Addendum 2 for RFB927940-01

Project Name: WRC Decentralization Phase 4 & Fire Alarm Phase 3 Bid Issuance #1
DAS RFB #: 927940-01
DAS Project #: 9279.40
Date: 05/15/2025

BASEMENT DEMOLITION AND FLOOR PLAN

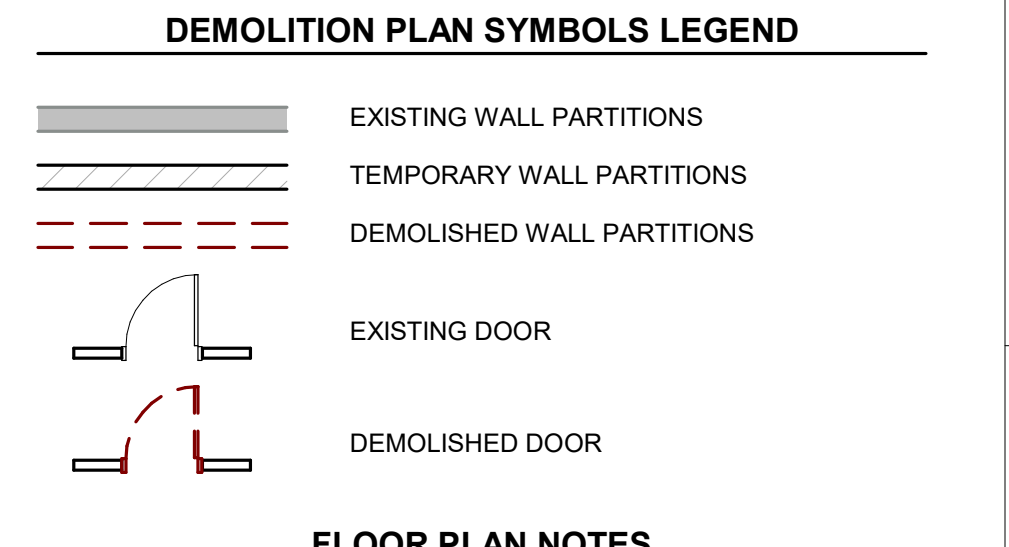
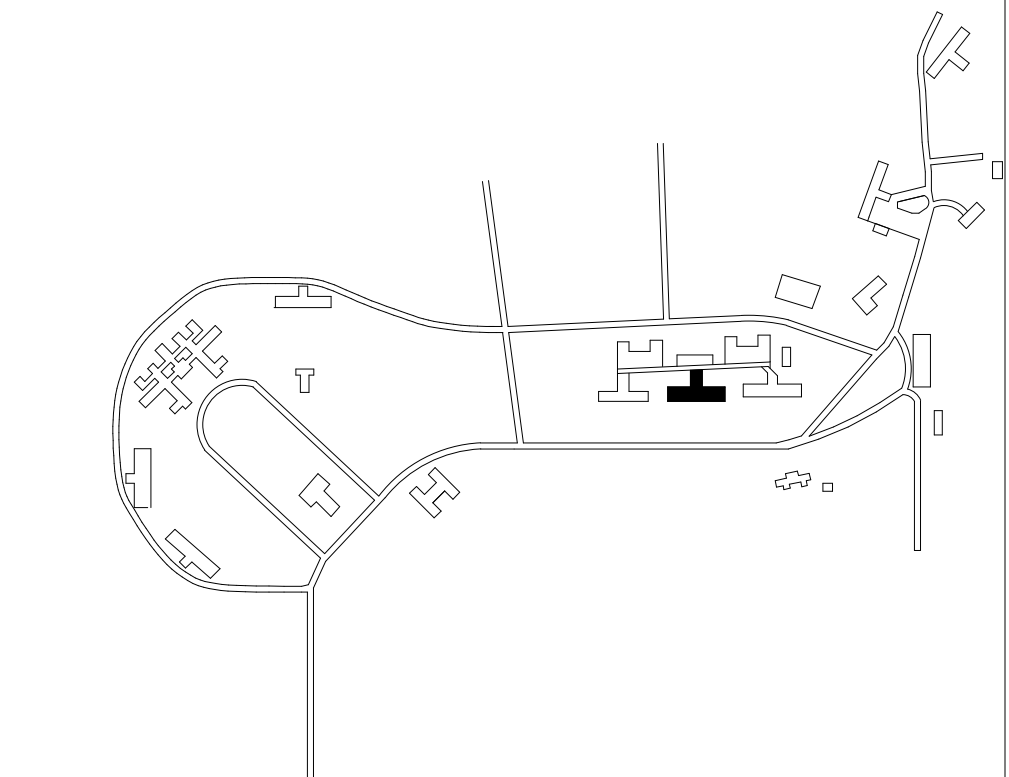
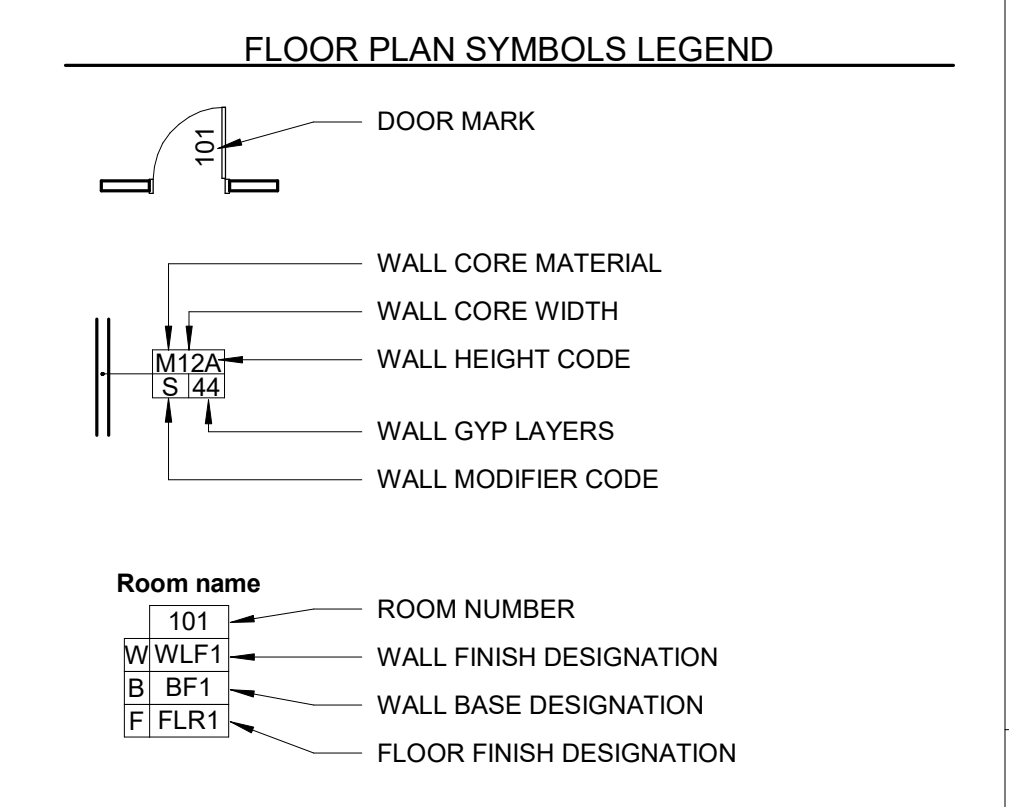
- **10-AD00 – BASEMENT DEMOLITION AND FLOOR PLAN**
 - **ADD** demolition of window (by Bid Package #01-1) in Storage B38A
 - **ADD** window infill (by Bid Package #23-1) in Storage B38A
- **10-M100- BASEMENT MECHANICAL PIPING PLAN**
 - **ADD** Piping Tags for Chilled Water in mechanical room.
 - **ADD** Make Up Water to chilled water system and Keynote 10-M122.
 - **REVISE** Outdoor Air Duct Size
 - **REVISE** Refrigerant Piping Routing.
 - **REMOVE** CUH-1 Tag shown on existing CUH.
- **10-M600 MECHANICAL SCHEDULES AND DETAILS**
 - **REVISE** Lintel Detail

BASEMENT DEMOLITION AND FLOOR PLAN

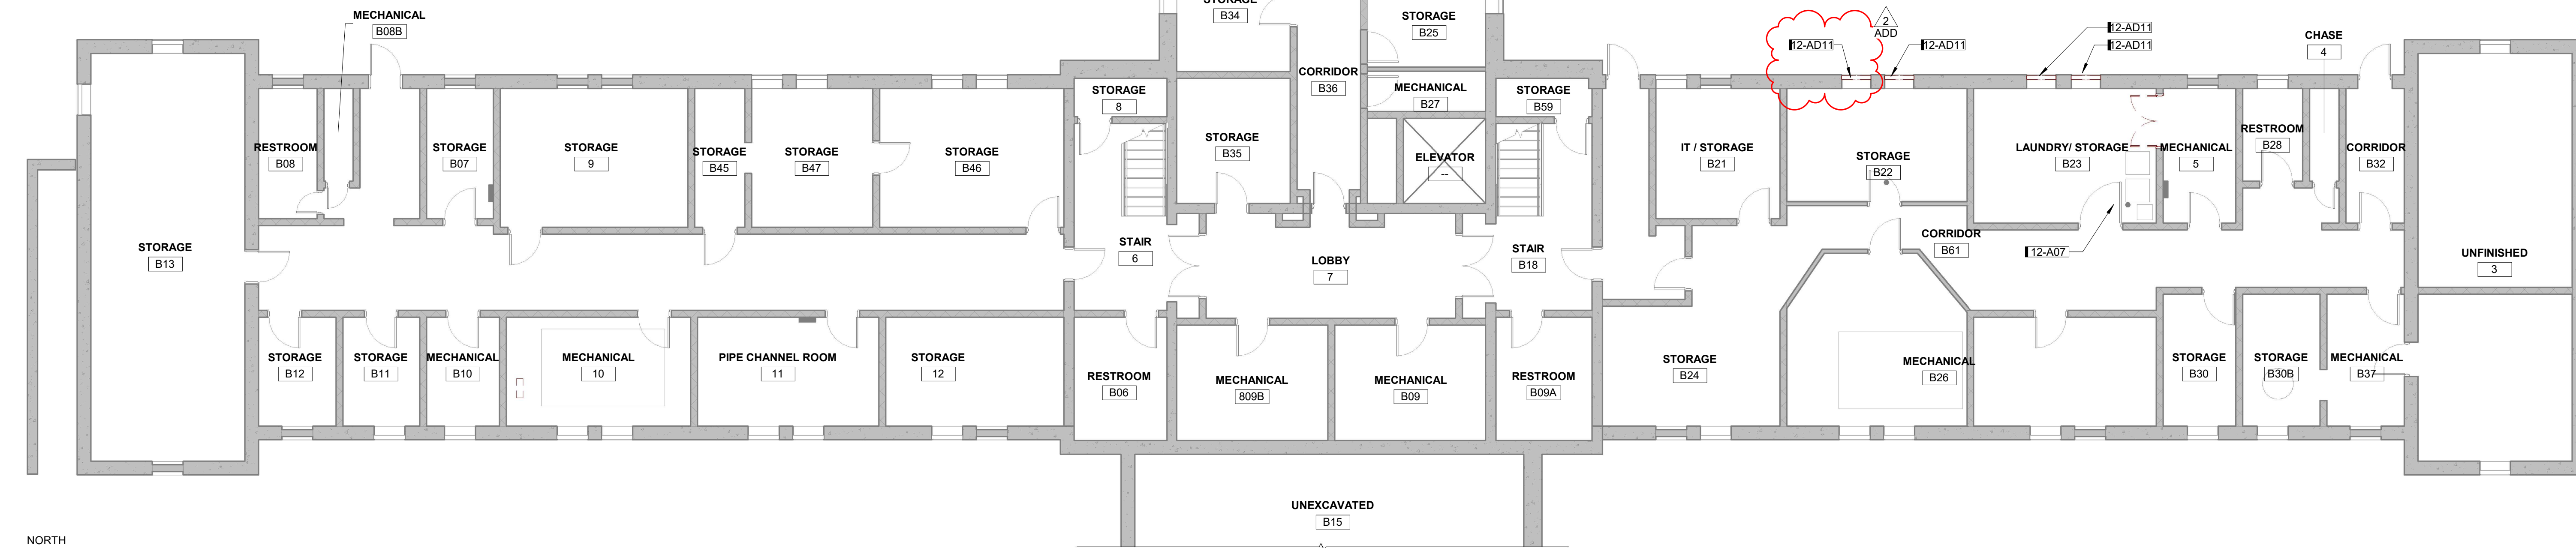
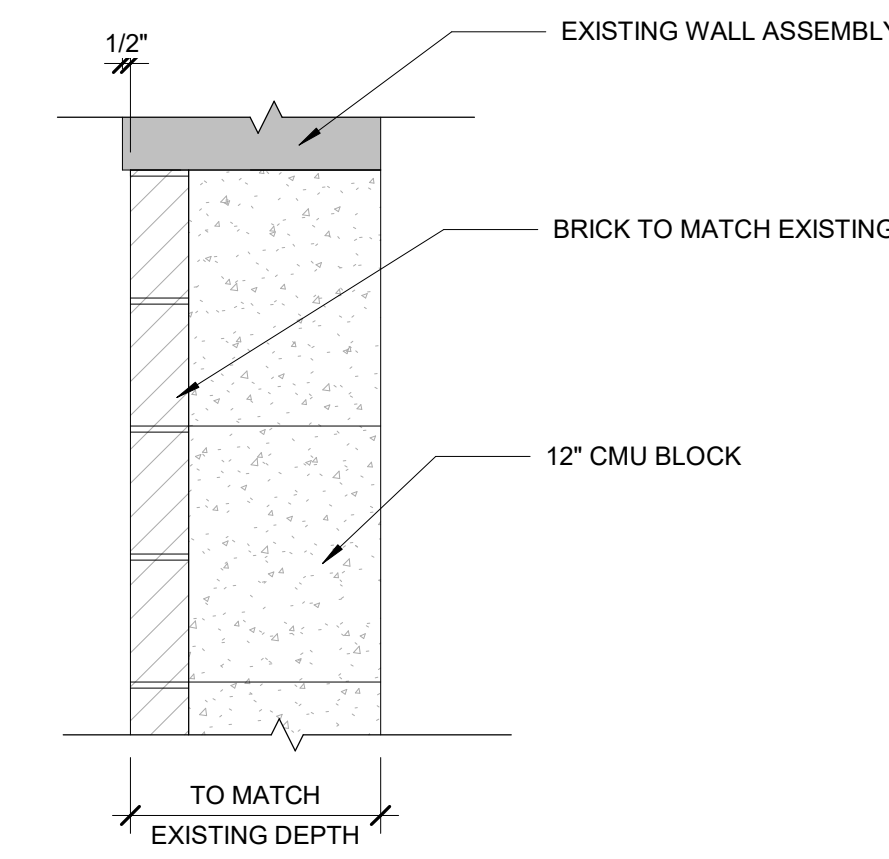
- **12-AD00 – BASEMENT DEMOLITION AND FLOOR PLAN**
 - **ADD** demolition of west window (by Bid Package #01-1) in Storage B22
 - **ADD** window infill (by Bid Package #23-1) in Storage B22

1 ENLARGED CHILLER ROOM
1/4" = 1'-0" 0 12'

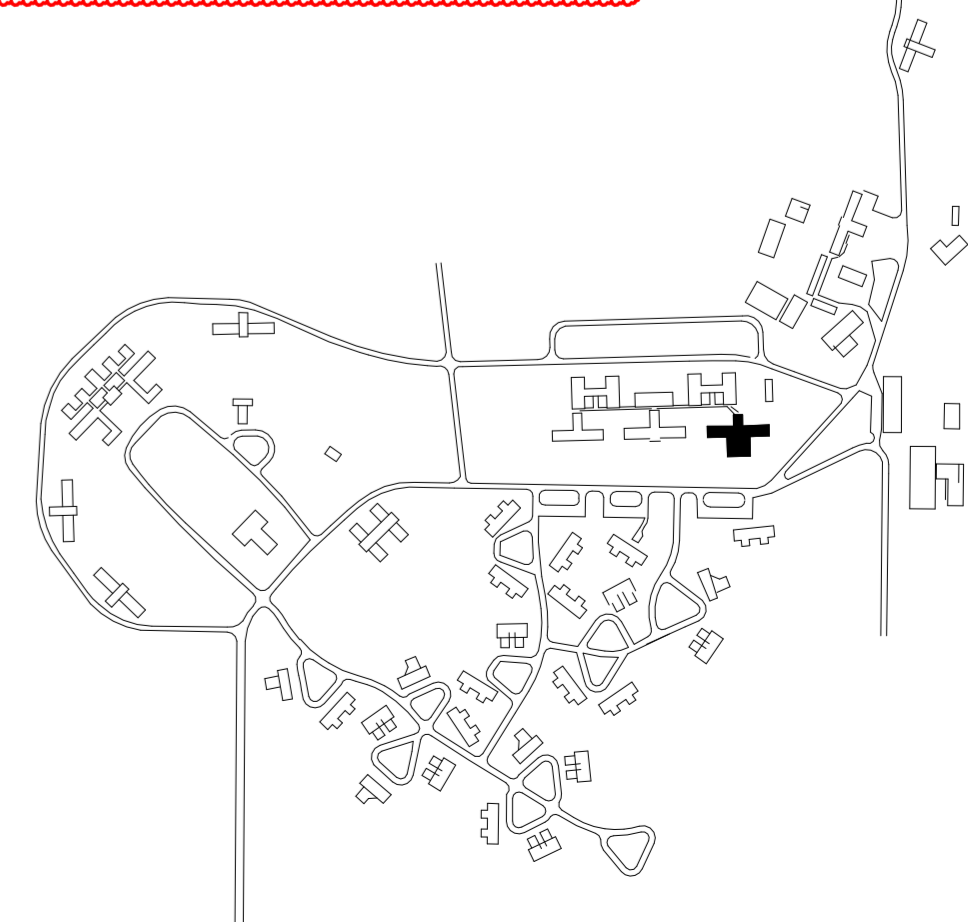
- **12-M100 BASEMENT MECHANICAL PIPING PLAN**
 - **ADD** Enlarged Chiller Plan
 - **REVISE** Exhaust System Ductwork and Keynote 12-M125.
- **12-M600 MECHANICAL SCHEDULES AND DETAILS**

B3) TYPICAL INFILL AT WINDOW HEAD
1 1/2" = 1'-0" 0"

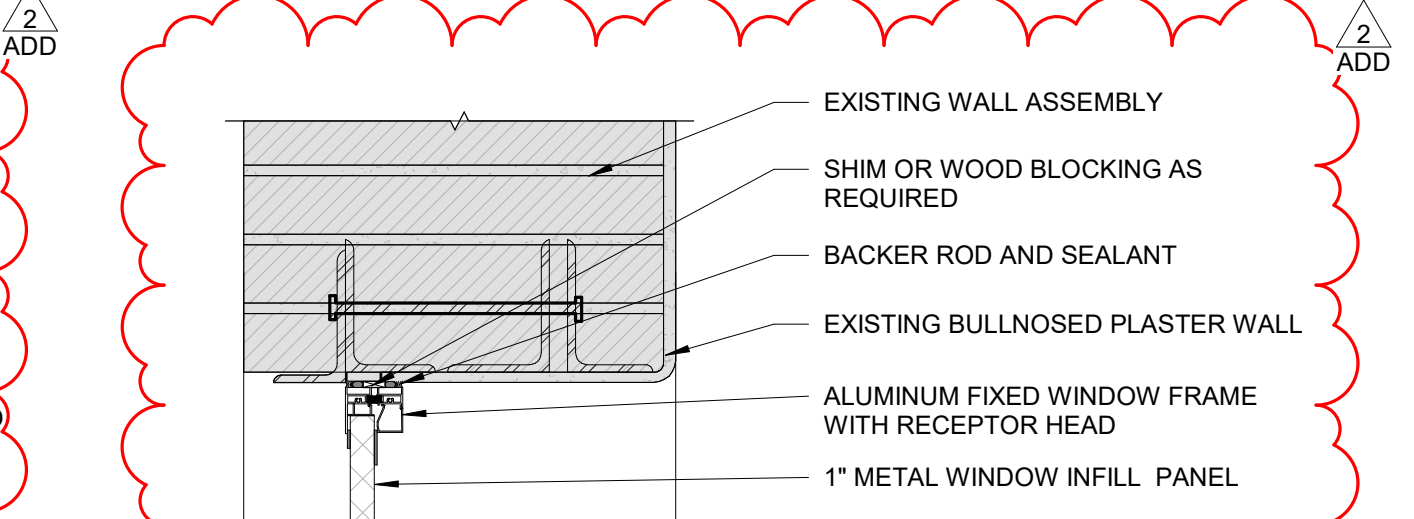
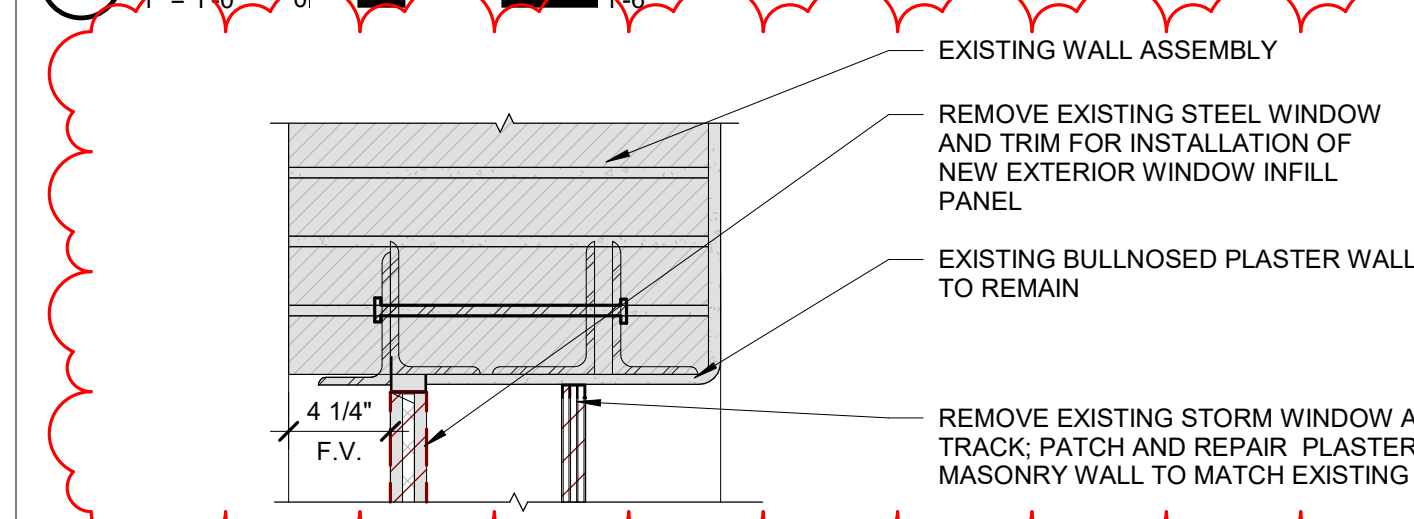
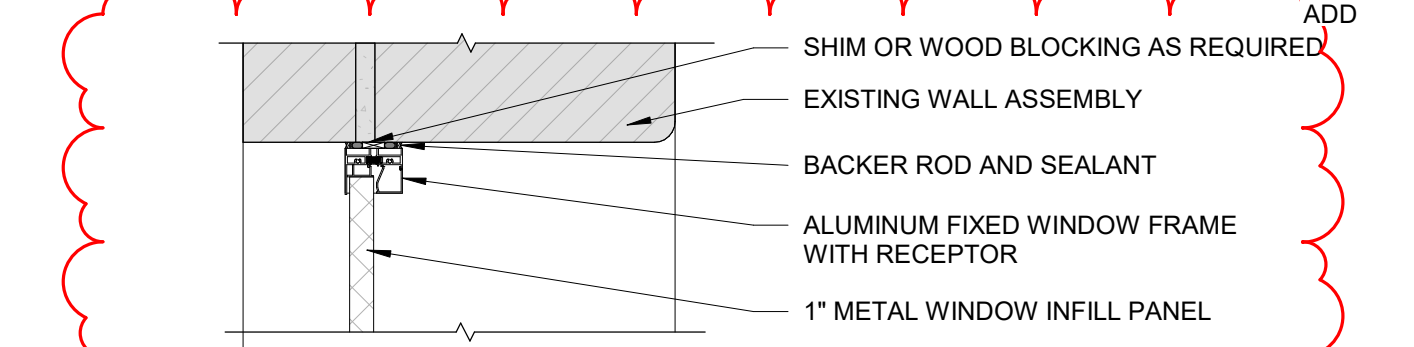
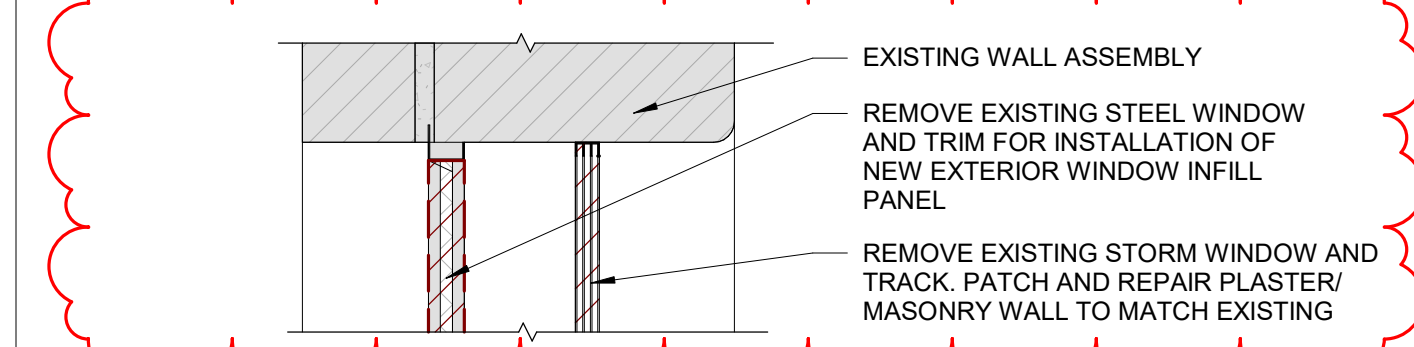
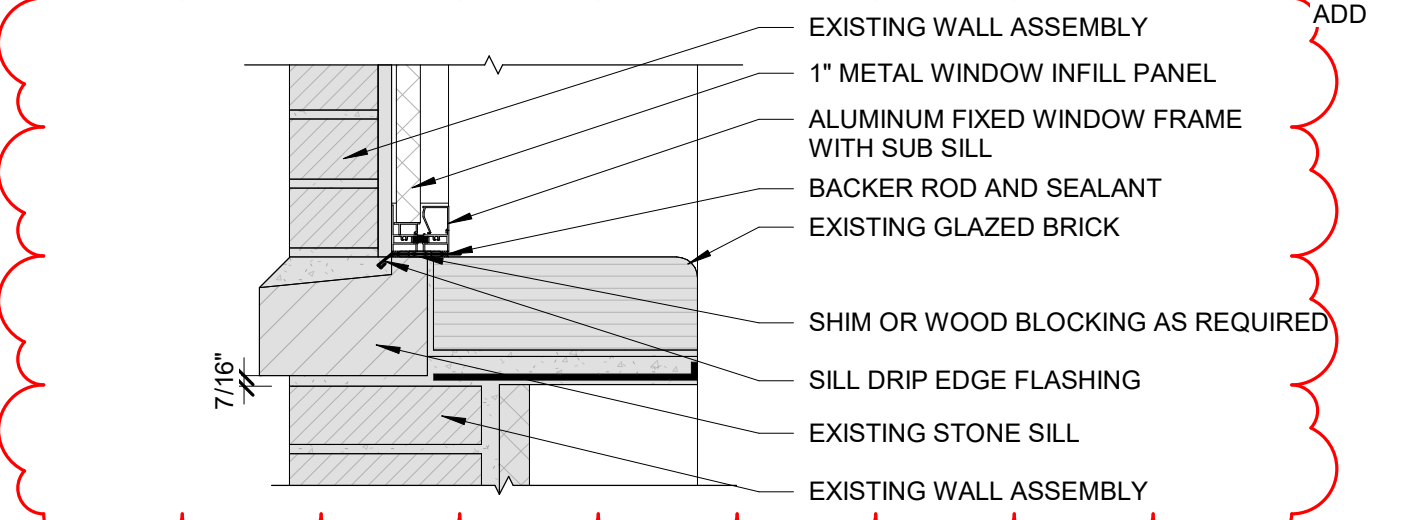
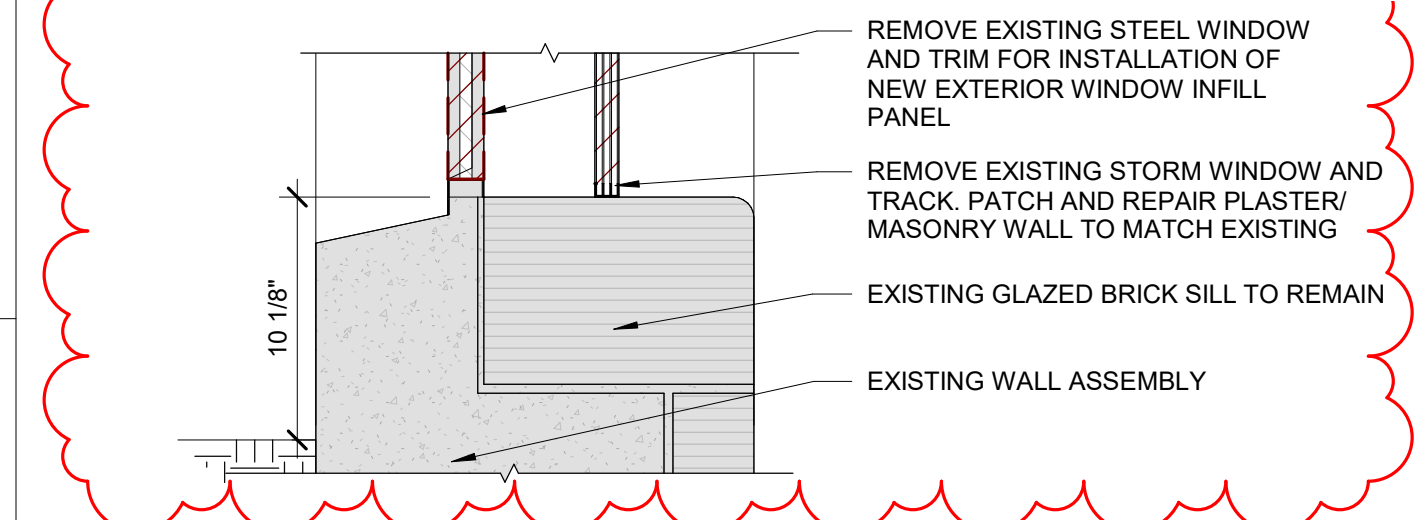
- **16-A102 – SECOND FLOOR PLAN AND THIRD FLOOR PLAN**
 - **REVISE** typical window demolition details
 - **REVISE** typical window infill details
 - **ADD** typical window infill elevation

G4) TYPICAL EXISTING WINDOW CONDITION
NOT TO SCALE

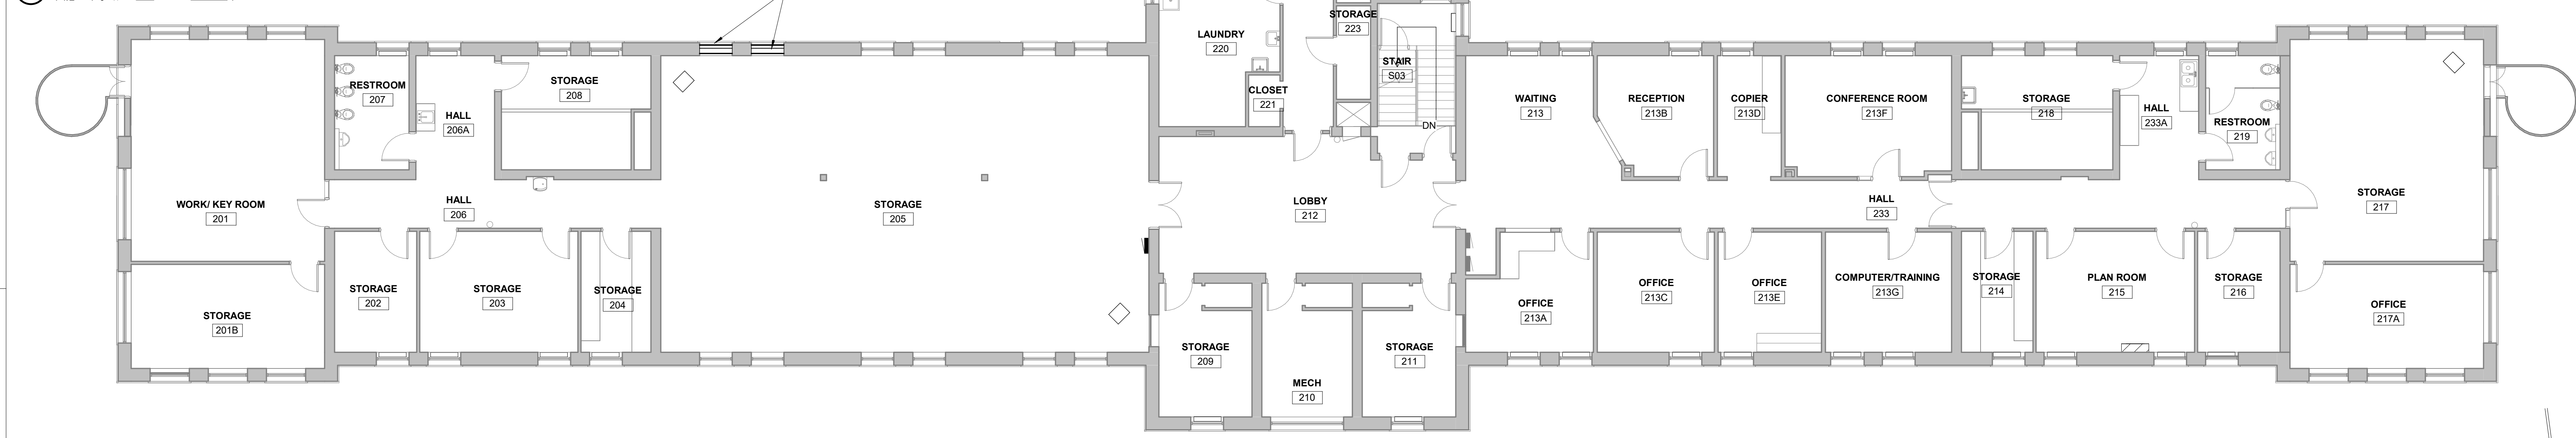
- **ADD** typical existing window condition photo
- **16-M100 - BASEMENT MECHANICAL PIPING PLAN**
 - **ADD** sheet in its entirety. (by Bid Package #23-1)
